**EXH. KKD-__X
DOCKET UE-210795
2022 PSE CEIP
WITNESS: KARA K. DURBIN**

In the Matter of
PUGET SOUND ENERGY, INC.
2021 Clean Energy Implementation Plan

Re: Puget Sound Energy 2021 Draft Integrated Resource Plans for Electricity and Natural Gas,
Dockets UE-200304 (electricity) and **UG-200305** (natural gas)

The NW Energy Coalition (“NWECC” or “Coalition”) appreciates the opportunity to comment on the draft Integrated Resource Plan (“IRP”) submitted by Puget Sound Energy (“PSE”) on January 4th, 2021, as provided by the Notice of Opportunity to File Written Comments issued January 5th.

Figure 3-2: Draft Preferred Portfolio Meeting Electric Peak Capacity

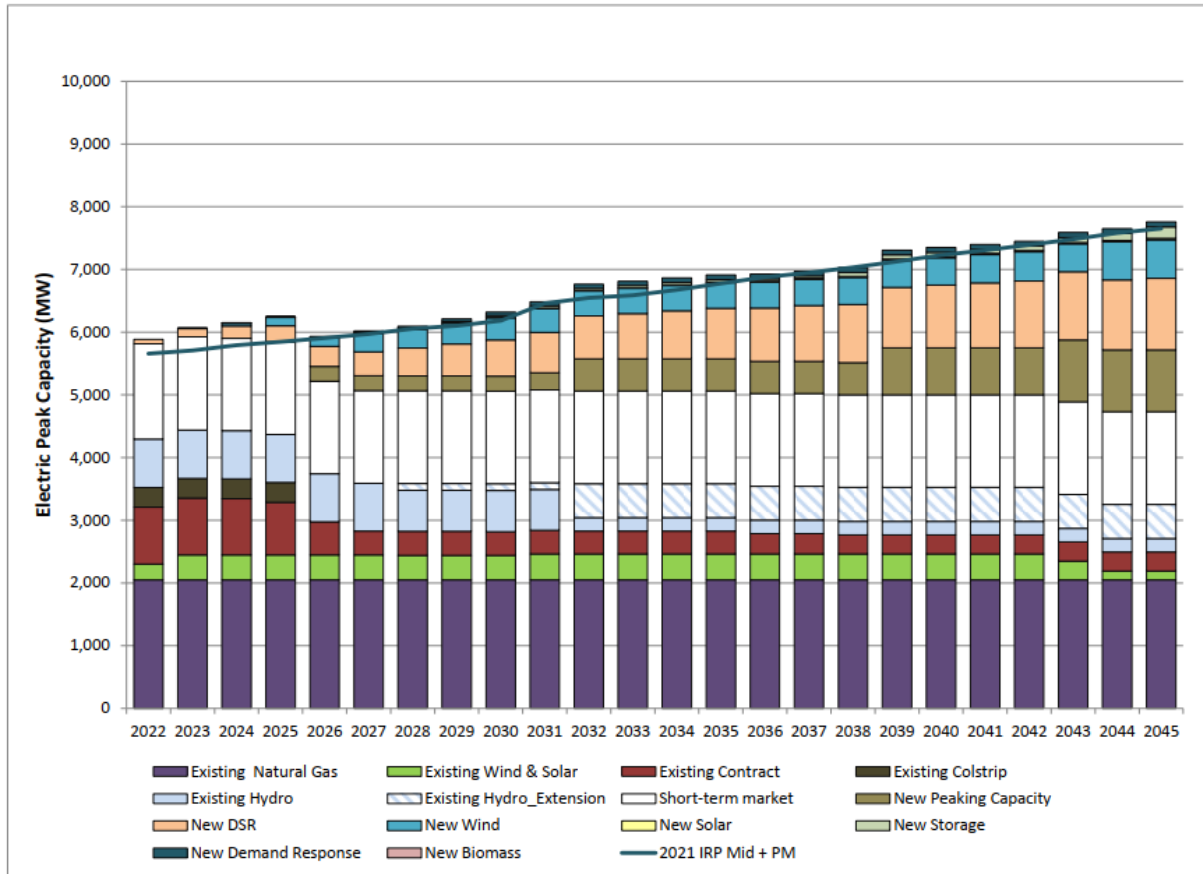
In 2027, the draft IRP indicates a need for 527 MW of capacity after inclusion of existing resources and new demand side resources. The draft proposes to fill this gap with 1100 MW of new wind, a small amount (around 20 MW) of demand response, and a 237 MW natural gas peaking plant (combustion turbine). These are estimates based on Figure 3-2, because the IRP only provides specific data for new resource additions in multi-year blocks, not annual values (Figure 3.1).

As we note in the following discussion, the 2027 resource additions do not provide a balanced new resource portfolio. In particular, the need for a new gas peaker is considerably in doubt.

Figure 3-14: Loss of Load Hours for 2027

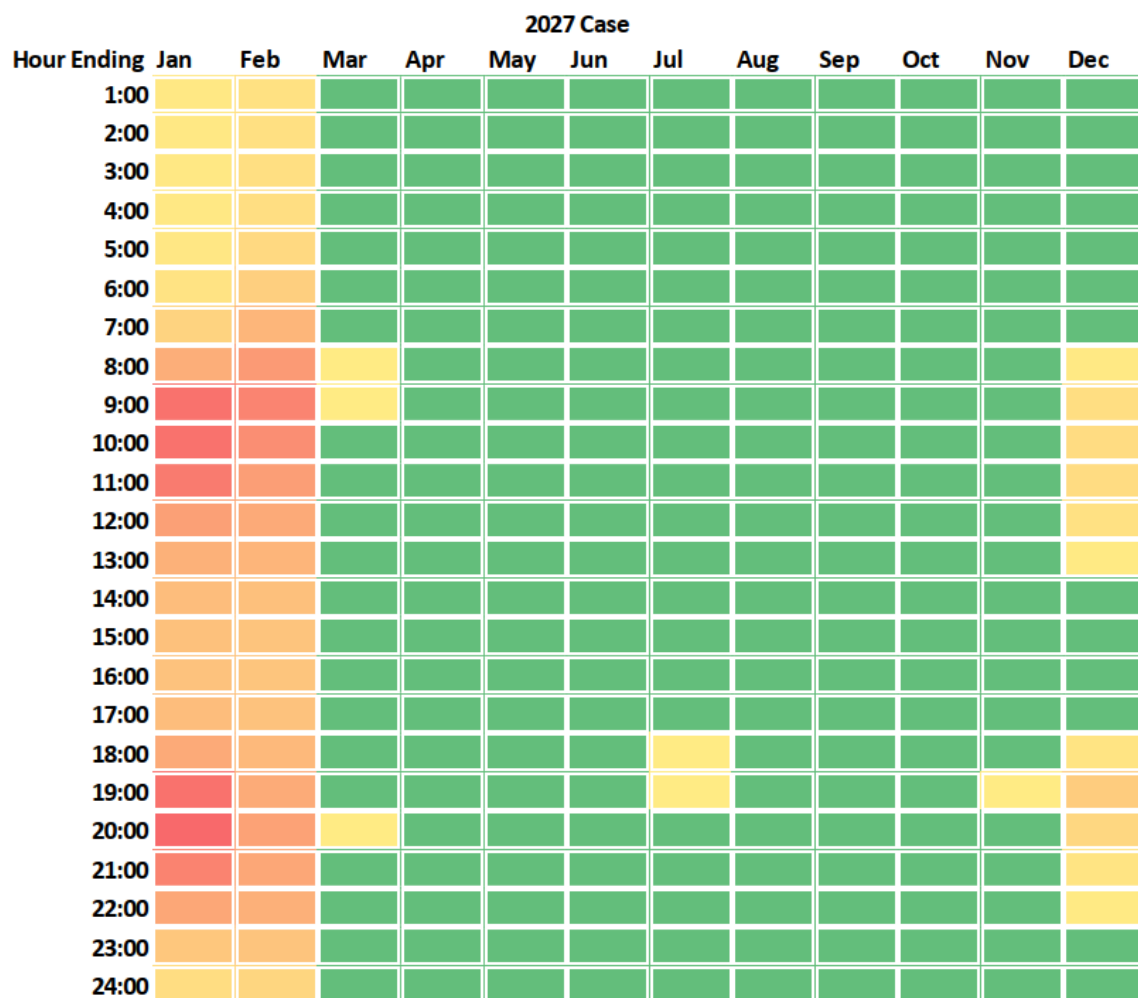
Figure 3-14 illustrates the challenge, showing stress conditions based on peak load duration in 2027. These conditions do not occur year-round, but almost entirely in the mid-winter quarter from December to February.

The draft IRP proposes to fill the 2027 gap with peak-oriented renewable resources -- primarily Montana wind, providing CETA-compliant clean energy up to the limit of available transmission -- a small amount of demand response, and a new 237 MW natural gas peaker plant. The question we pose is whether a staged approach to capacity need could provide a new balanced 2027 resource portfolio that is better aligned with CETA policy guidance while meeting reliability needs cost-effectively:

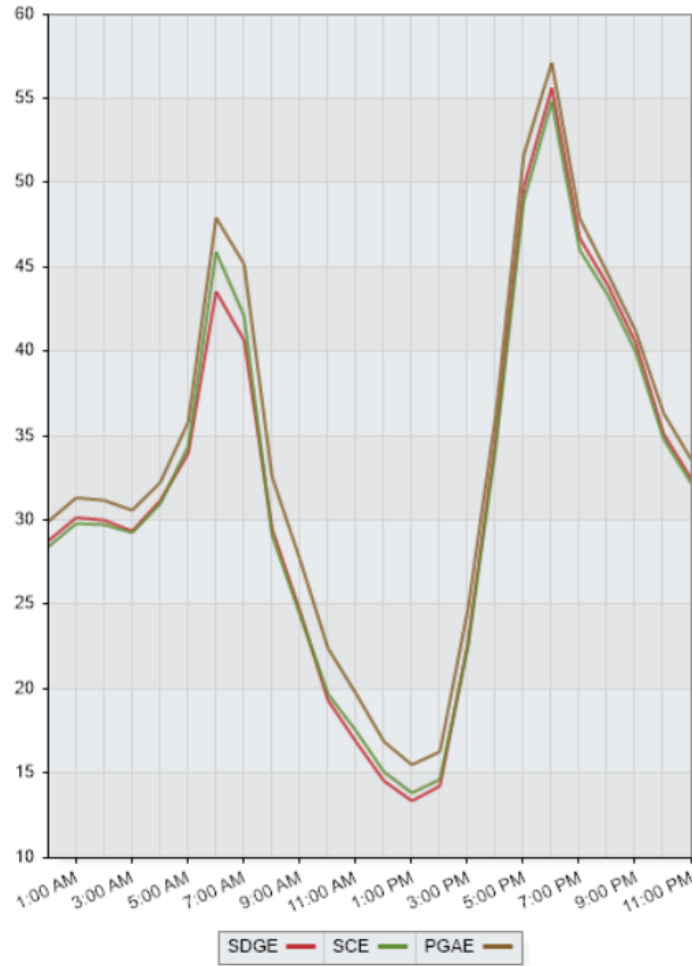
While these values are based on California ISO summer peak and wind in the BPA Balancing Area, primarily “Gorge wind” with a low summer capacity factor, the effect of battery availability to shift energy to peak periods is clear – from 32.8% to 90%.

Re-examining hybrid potential is especially important for PSE given the heavy reliance of the draft preferred portfolio on Montana and Wyoming wind. With limited available transmission and high winter peak needs, hybrid wind+battery or wind and associated pumped storage could provide significant additional peak capacity.

CAISO (California ISO)
Day-Ahead Price

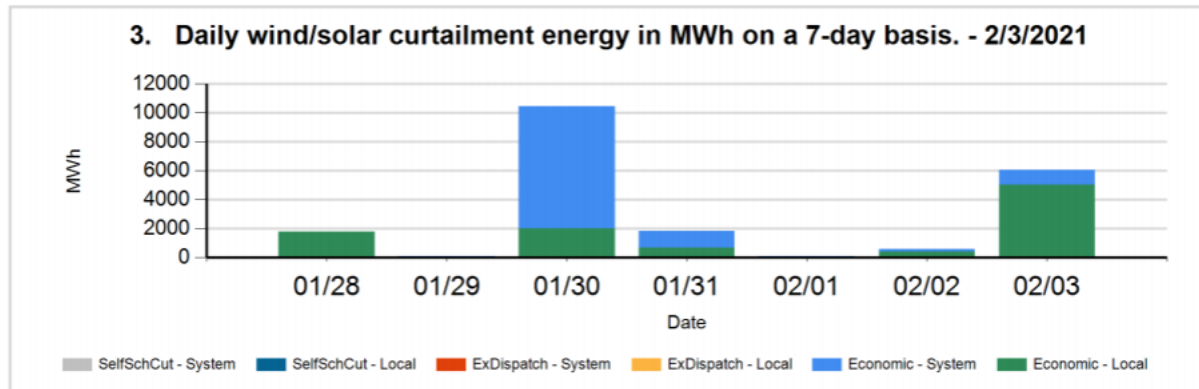
For example, on Feb. 3, California ISO day-ahead market prices averaged less than \$20/MWh between 10 am and 3 pm. In addition to substantial standby gas capacity, mid-day solar is often curtailed during the winter, providing another source of very cheap and clean energy. In the past week over 2,000 MWh/day of solar was curtailed in CAISO for economic reasons. PSE should study the potential for acquiring California winter surplus to meet winter peak needs. The exact form of such purchases requires considering a range of term offers, but we provide a back-of-the-envelope example.

Example: Assume 250 MW of firm energy for 100 midwinter on-peak hours delivered from California for \$100/MWh including transmission wheeling charges. That amounts to \$2.5 million per year. With the availability of sufficient flexible load and storage resources, instead of buying on peak hours, California surplus could be acquired in the very low-cost mid-day period with a much higher renewable energy content. All this suggests that imports could be far cheaper than a new gas peaker.
